REGIONAL REVIEW FINDING

ARC REVIEW CODE: R1701241

Name of Proposal: SL Bright Star (DRI #2653)

CONCEPTUAL SITE PLAN
OF
BRIGHT STAR ROAD PROJECT DRI # 2653
L.L. 162 & 163, 2nd DISTRICT, 5th SECTION
CITY OF DOUGLASVILLE, DOUGLAS COUNTY, GEORGIA

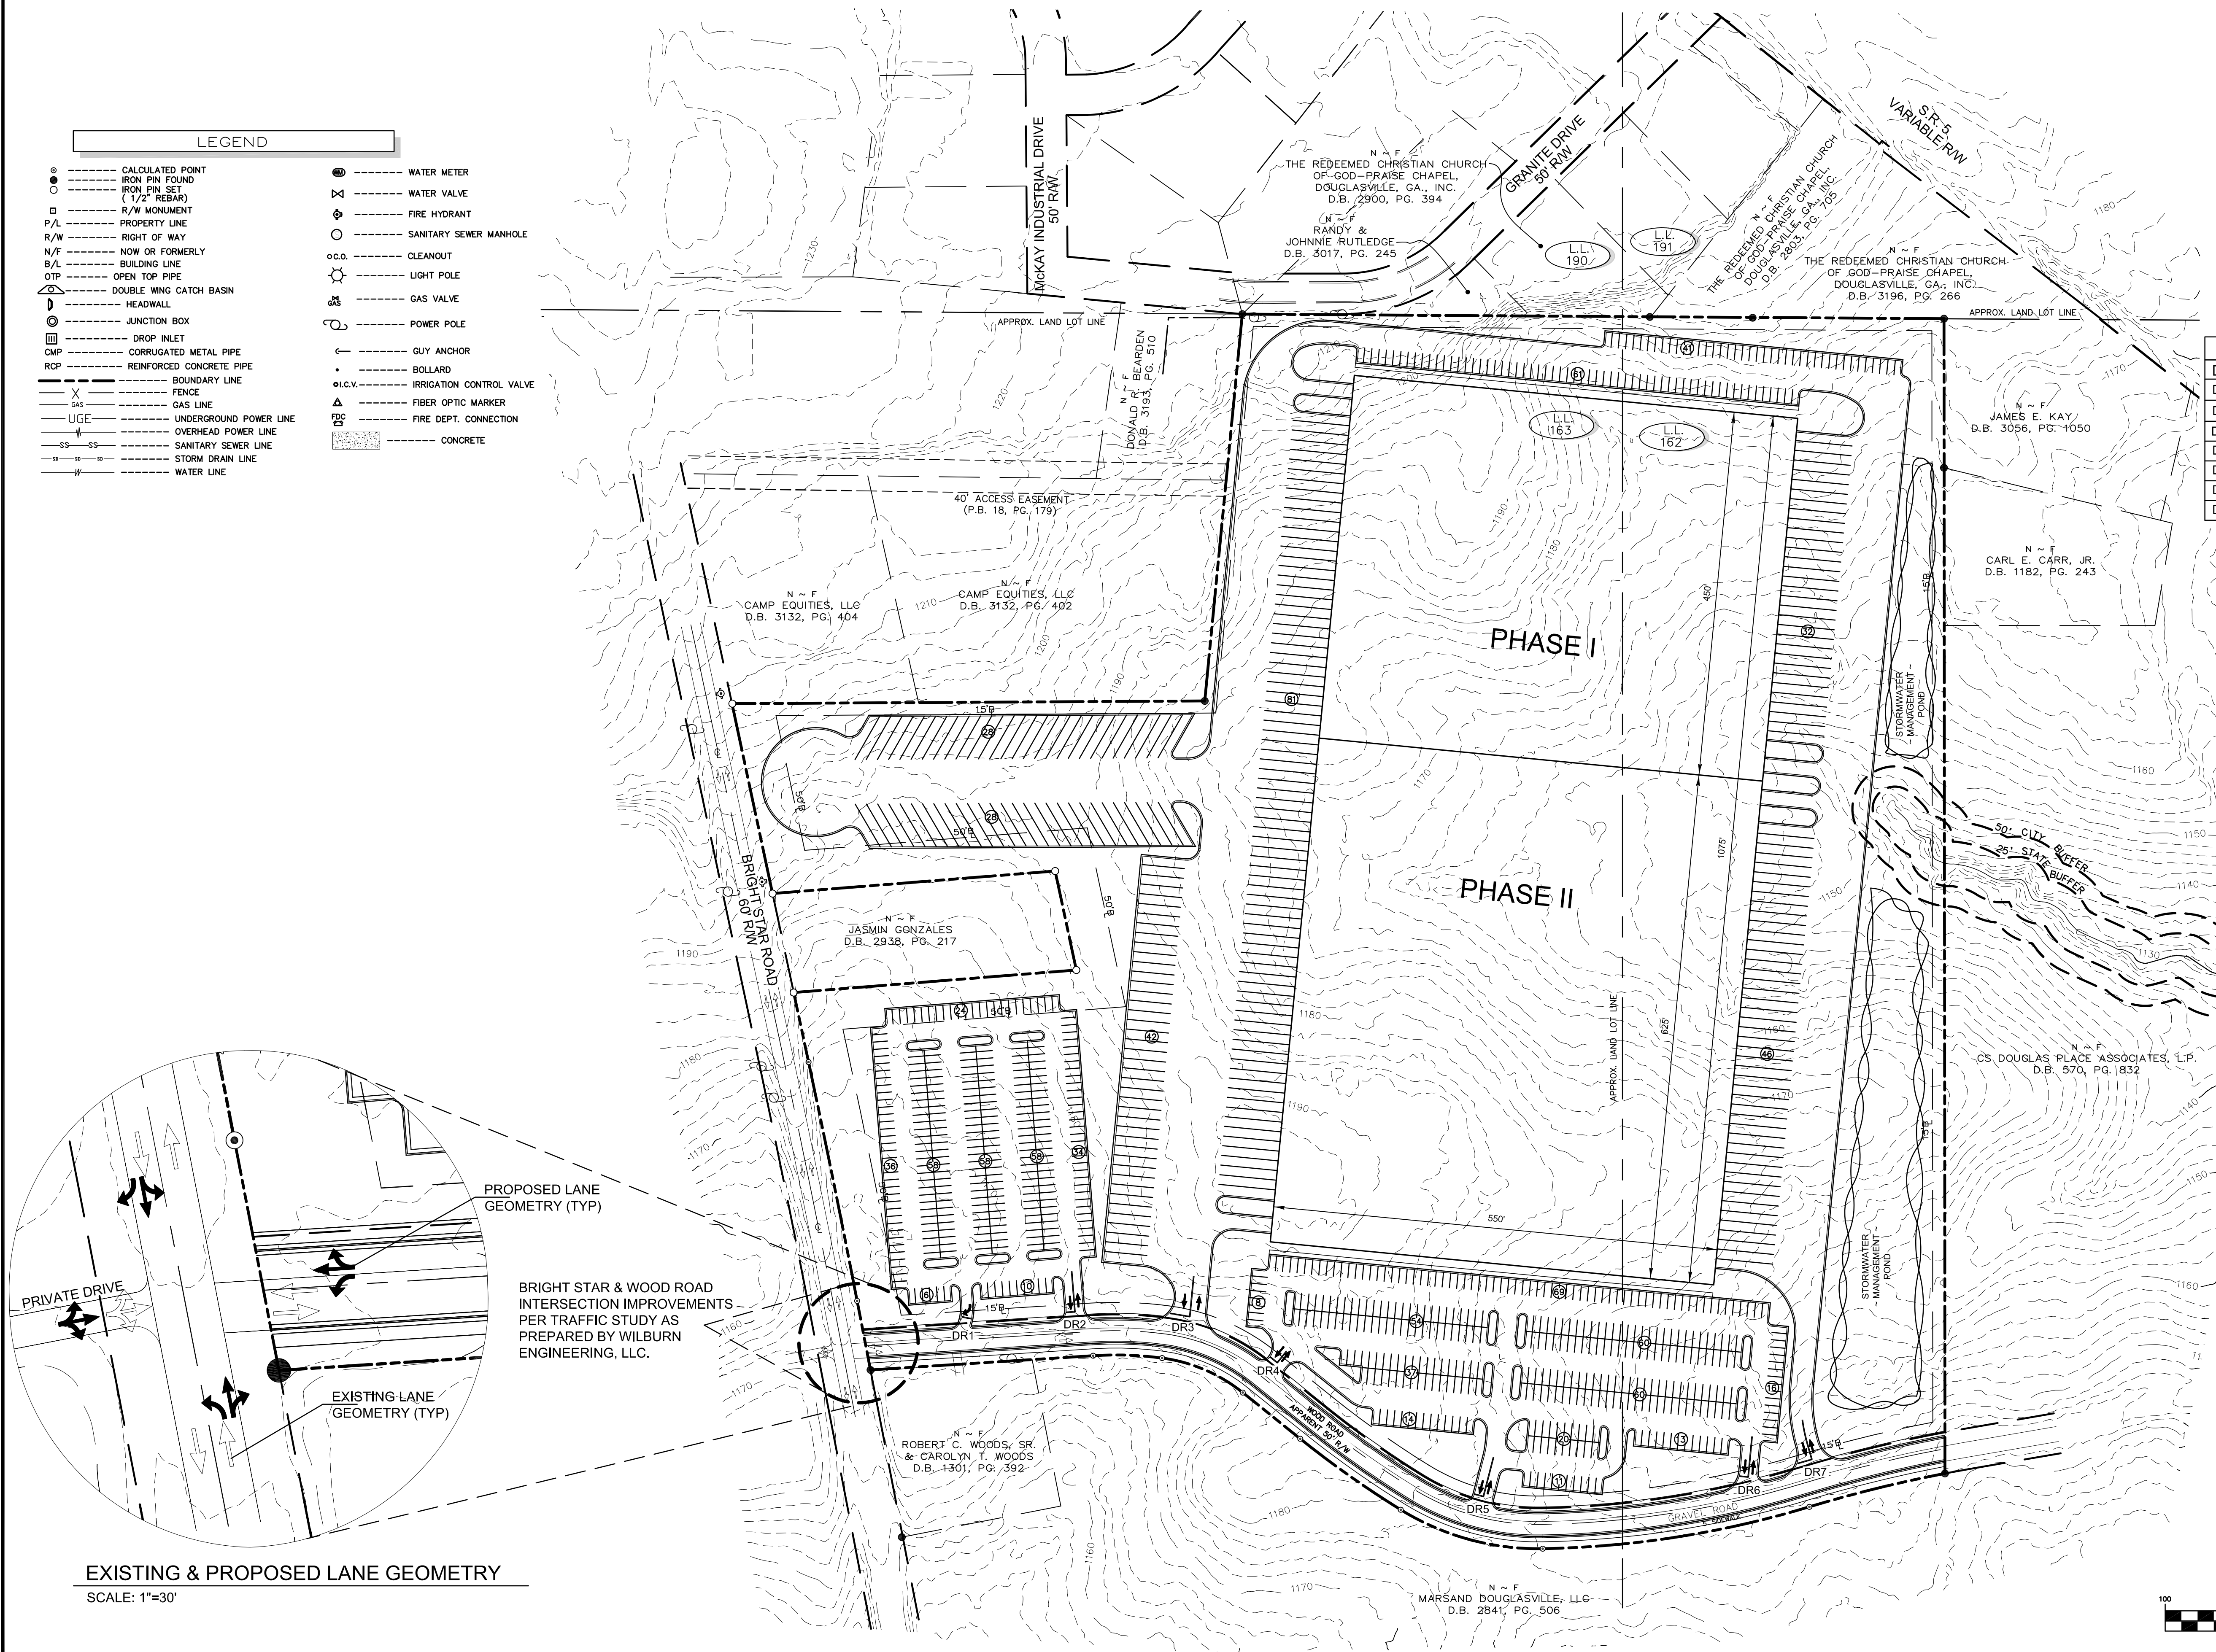
The USGS coverage for the project area shows a blue line stream that is either the headwaters of Anneewakee Creek or a direct tributary originating on the property. The project site plan shows the stream as starting at the eastern edge of the property, just east of a proposed driveway/parking area. The submitted site plan shows that driveway area intruding on the City's 50-foot stream buffer at the headwaters of the stream. It also intrudes on the City's additional 25-foot impervious setback, which is immediately adjacent to the buffer and is part of the buffer ordinance. Regardless of the stream's location, any intrusion in the buffer or setback will be subject to the requirements of the City of Douglasville's Stream Buffer Ordinance. Any unmapped streams on the property may also be subject to the requirements of the City's Stream Buffer Ordinance. In addition, all streams on the property, as well as all waters of the state, are subject to the requirements of the State Erosion and Sedimentation Act, which includes a 25-foot buffer on all state waters.

The subject site is bounded by existing industrial uses on the northern and western boundaries. Parcels east and south of the site remain undeveloped. The development does not propose additional roadways or stub-outs that may provide future interparcel connectivity. It should be noted that Wood Road is currently unpaved. The development is projecting about 2,500 trips per day and proposing seven access drives from Wood Road.

The subject site proposes seven (7) access points off Wood Road. Five of the access points feed into designated parking lots while the other two are drive lanes spanning the entire site. This method appears to segregate proposed employee and visitor vehicular traffic from truck traffic internal to the site.

Interconnectivity and accessibility between parcels is paramount to reduce congestion. The incorporation of opportunities for future interparcel connectivity external to the development site is encouraged.
